SUBJECT: PALISADES PLANT - ISSUANCE OF AMENDMENT RE: PRESSURE-TEMPERATURE LIMITS (TAC NO. M90650)

AMENDMENT NO. 163 TO FACILITY OPERATING LICENSE NO. DPR-20-PALISADES

SAFETY EVALUATION BY THE OFFICE OF NUCLEAR REACTOR REGULATION

RELATED TO AMENDMENT NO. 163 TO FACILITY OPERATING LICENSE NO. DPR-20

Figure 3-1
Pressure-Temperature Limits for Heatup

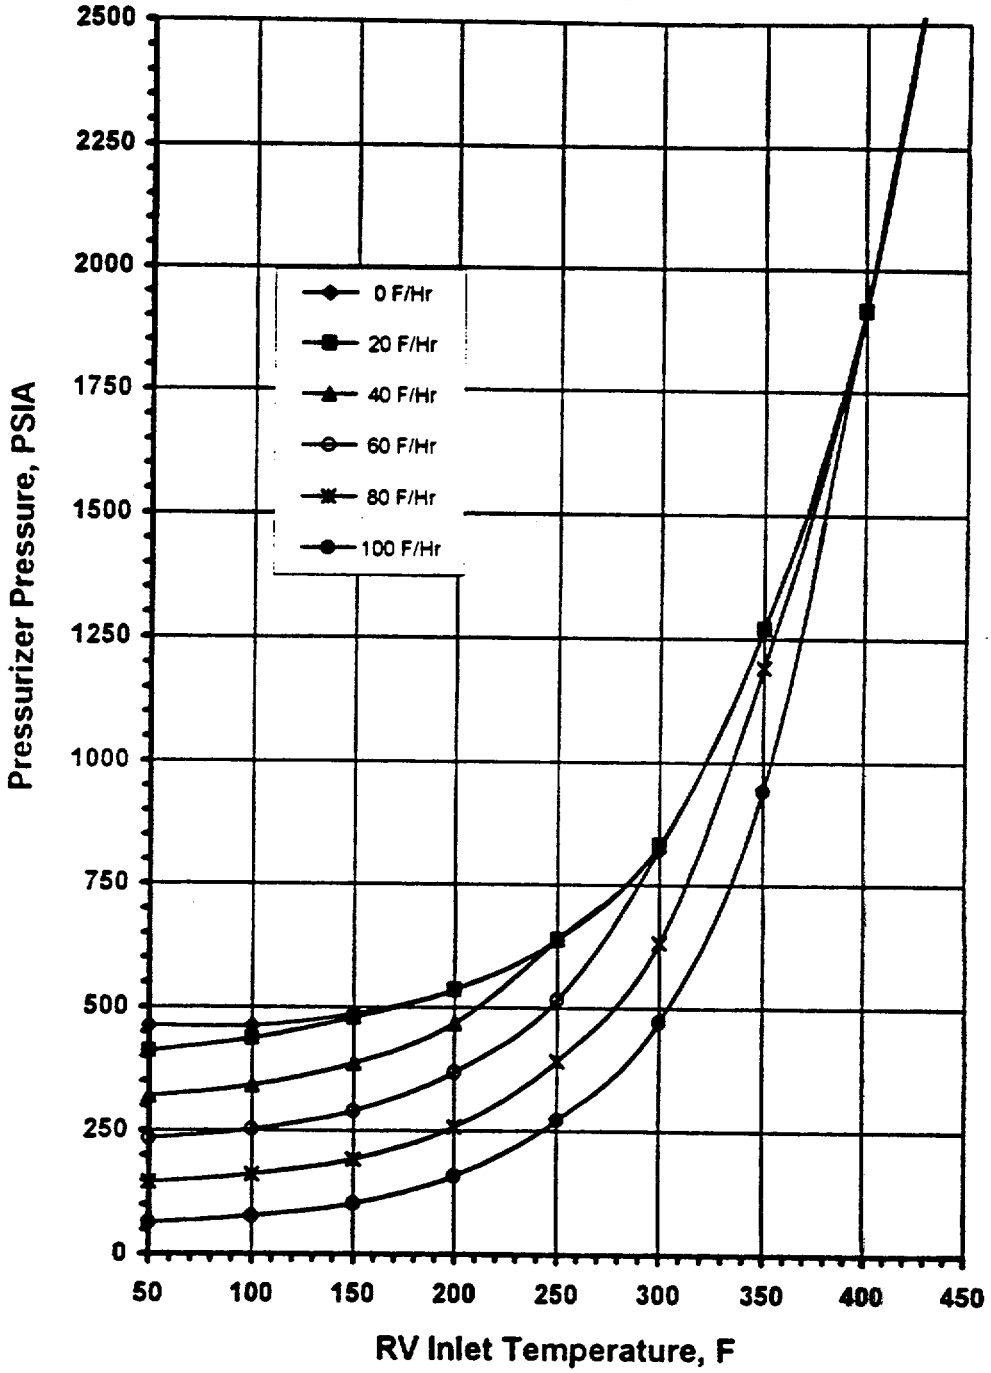
The staff has performed an independent analysis to verify the licensee's proposed P-T limits, and reviewed the chemical composition data from PTS discussions during the November 21, 1994, meeting. The staff concludes that the proposed P-T limits for heatup and cooldown are valid for a neutron fluence at the limiting weld of 2.192E19 n/cm^2, which corresponds to 6 EFPY from the beginning of cycle 10 because (1) the limits conform to the requirements of Appendix G of 10 CFR Part 50 and GL 88-11, and (2) the material properties and chemistry used in calculating the P-T limits are consistent with data submitted as part of the licensee's PTS evaluation and the staff's PTS assessment. Hence, the proposed P-T limits may be incorporated into the Palisades TSs.

CPCo proposed changes to the P-T curves in TS Figures 3-1 (for heatup) and 3-2 (for cooldown), to TS Figure 3-4 (for PORV setpoints), to TS 3.1.1h (for starting first PCP), and to TS 3.3 (for HPSI pump operability). The licensee states that the existing PCS P-T limits were based on a reactor vessel wall fluence of 1.8x10^{19}nvt. The changes in TS 3.1.1h and TS Figure 3-4 are intended to protect against P-T limits specified in the revised TS Figures 3-1 and 3-2. The revised TS 3.3 would allow the HPSI pumps to remain operable during low temperature operating conditions so that these pumps could be manually actuated for PCS makeup in case the shutdown cooling capability is lost. However, when the PCS temperatuare is less than 300°F, the HPSI pumps would be rendered incapable of injection into the PCS by manually interrupting the power supplies to HPSI pumps or by isolating the flow path.

Figure 3-4
LTOP Setpoint LIMIT

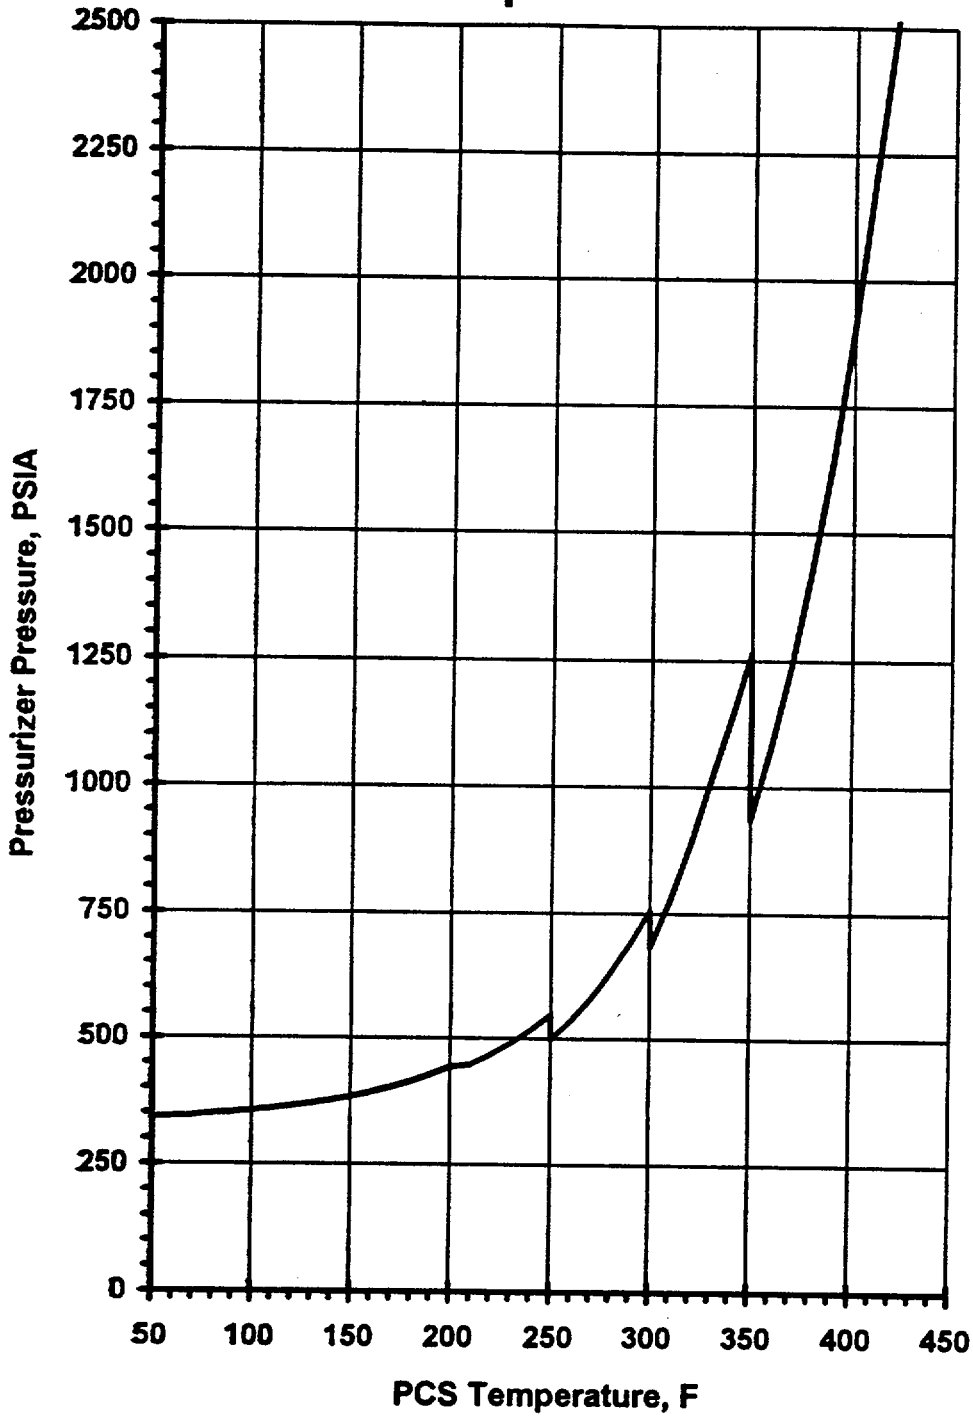
The most limiting energy addition transient assumed in the licensee's analysis is the start of the first idle PCP with secondary system temperature less than 100°F above the PCS cold leg temperature. The results of the analysis indicates that the transient PCS peak pressures are below their allowable P-T limits under isothermal conditions. The PCS was assumed in water solid condition prior to the transient for added conservatism in the licensee's analysis to support the proposed PORV settings.
